LAKE HAVASU CITY, ARIZONA

ADDENDUM NO. 2
Police Department Fueling Facility
PROJECT NO.103005

Date Issued: August 12, 2022
Bid Date: August 24, 2021
To: All Planholders of Record

Attachment A
Police Department Fueling Facility
PROJECT NO.103005

JACOBS
 CIVIL

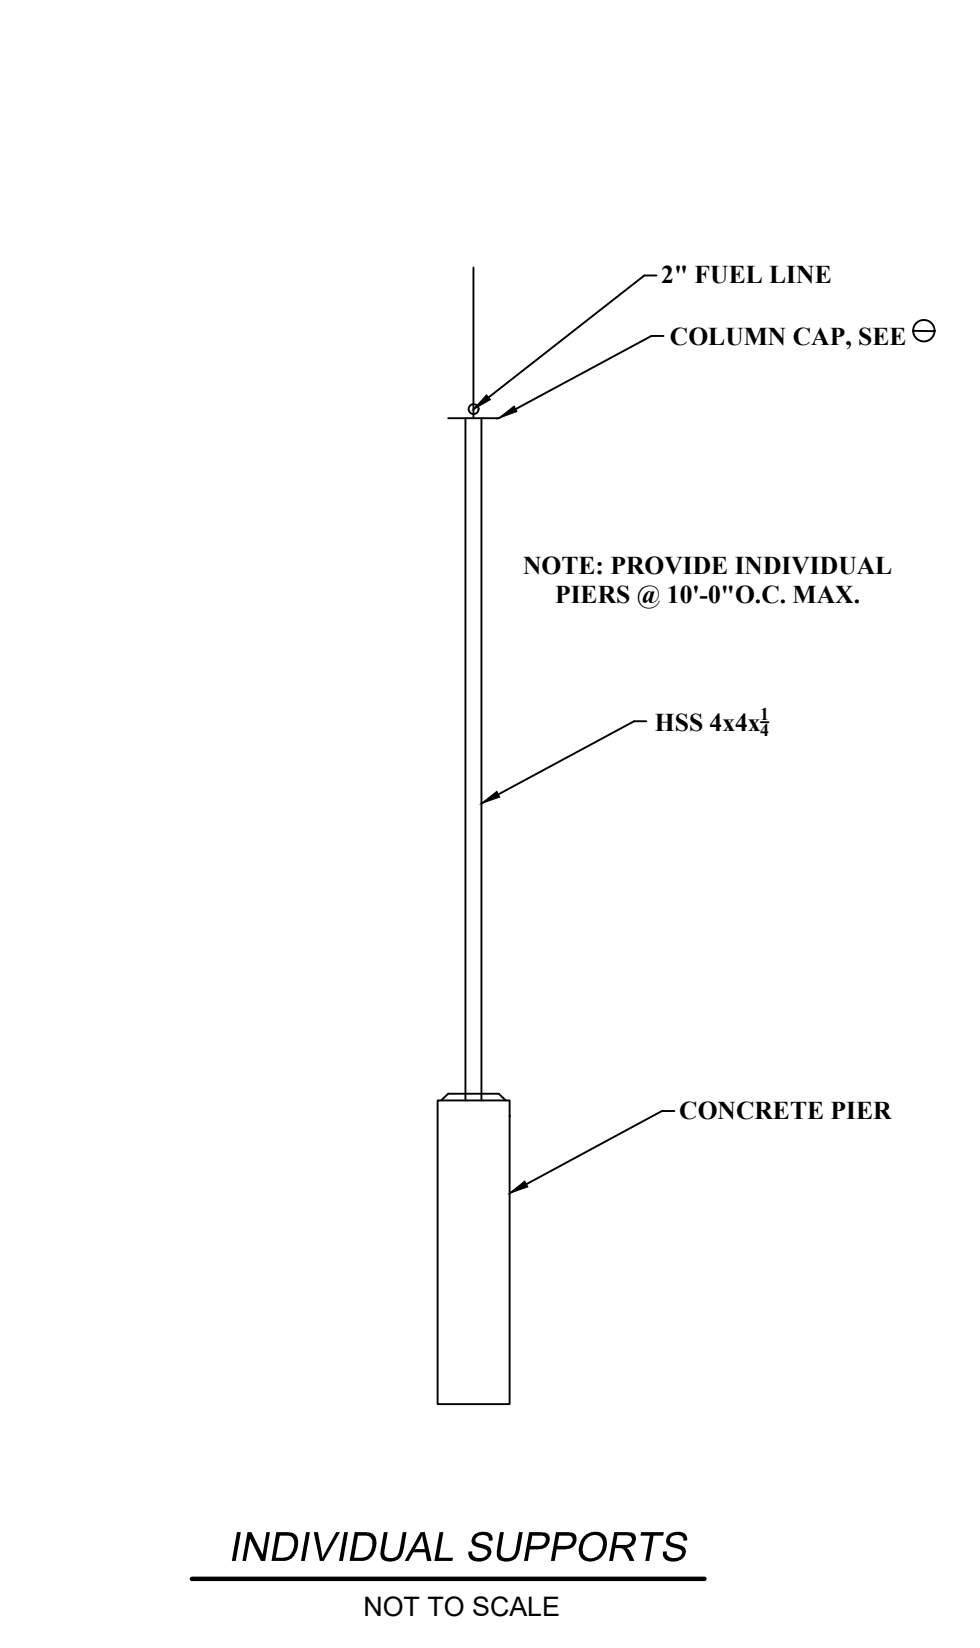
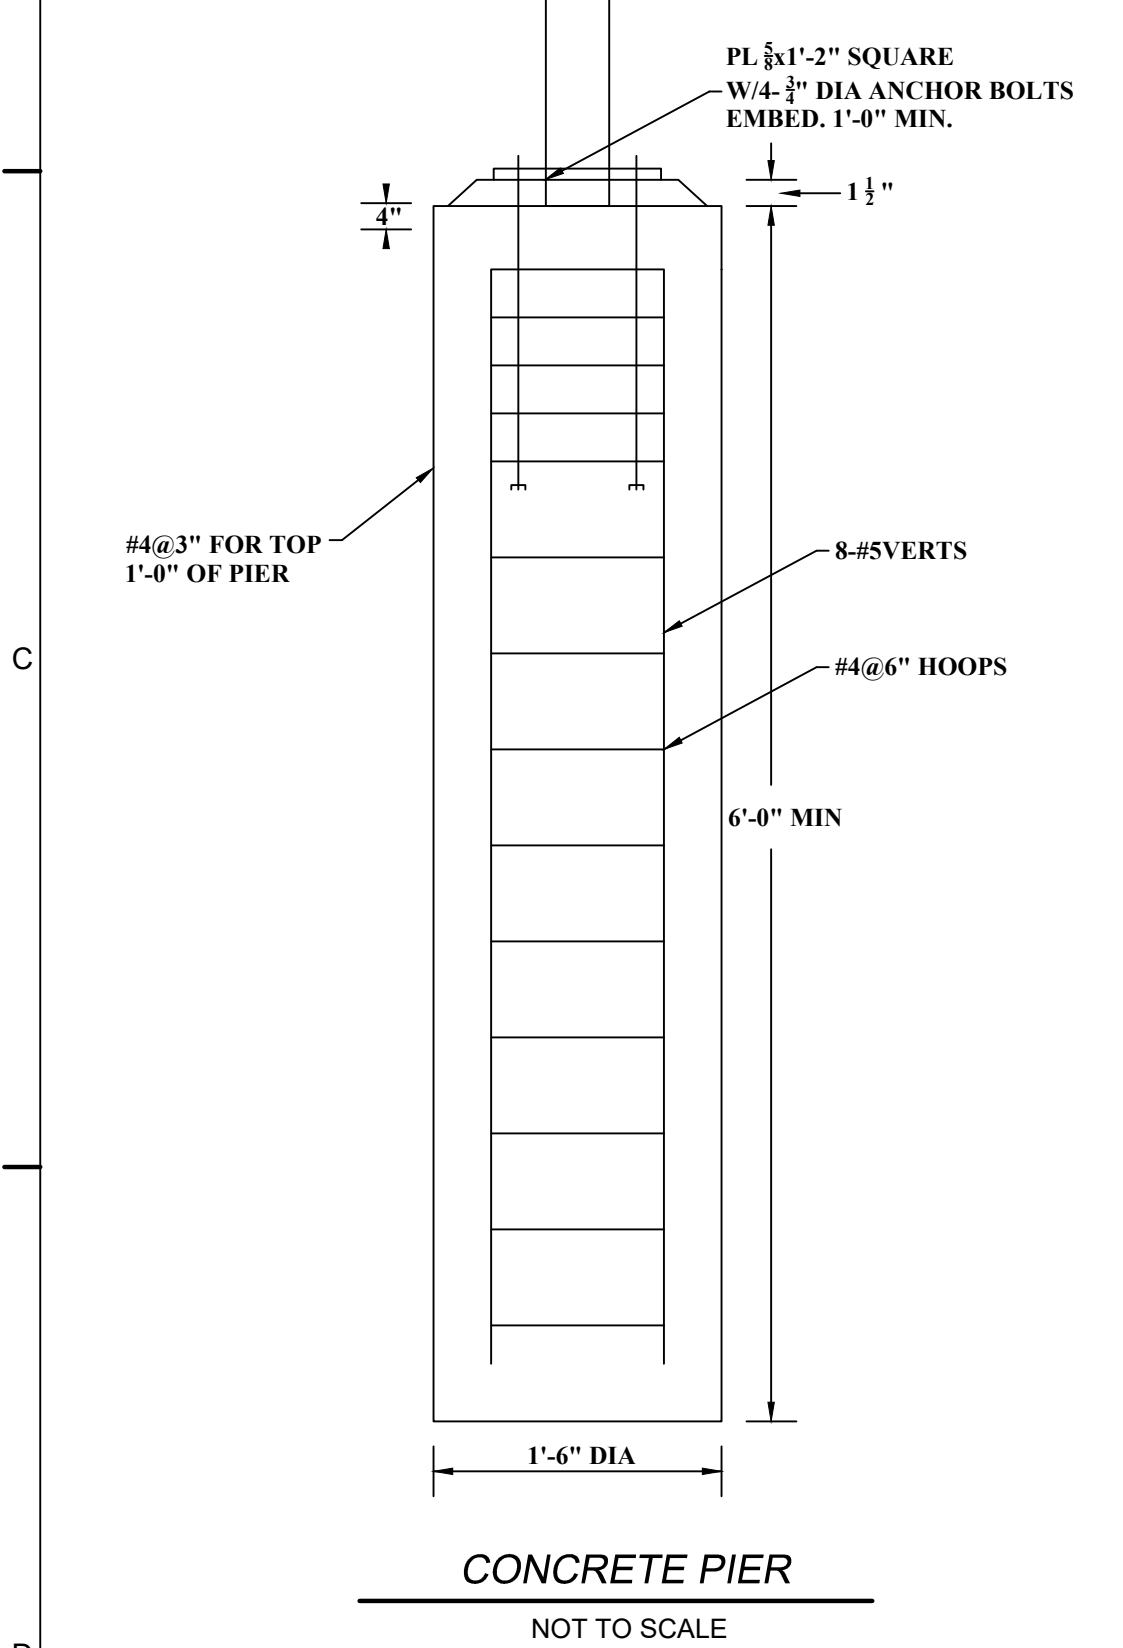
Item 3: Drawings C-2, C-3, and C-4 have been revised to:

1. Show an existing sewer line below the work area. Contractor to pothole and verify location and depth of the sewer line and the cleanout adjacent to the work area.
2. Better approximate the relative locations and slope of the existing sound wall and proposed retaining wall and tank slab.

DRAWING C-2 & C-3

Question 4: Please provide elevations for the new retaining wall slab and existing grade. Without this information we are unable to determine the amount of excavation required for the new fuel tank area and structure. This will also help determine the construction requirements for not undermining the toe of the existing screen wall footing as shown in the retaining wall detail.

Question 31: On sheet 3 there is a column called out with a base plate next to the fuel tank that is to be mounted to the slab. Currently the slab is called out to be 8" thick, and all the other columns have pier footings that are min 6' deep. Is the slab to be thickened at this one column or will a pier footing be required at this location?

Answer: Elevations were added to Drawings C-3 and C-4. Existing elevations were obtained from as-built drawings provided with this Addendum.

Answer: Neither thickening nor pier is required at the slab to withstand overturning moment.
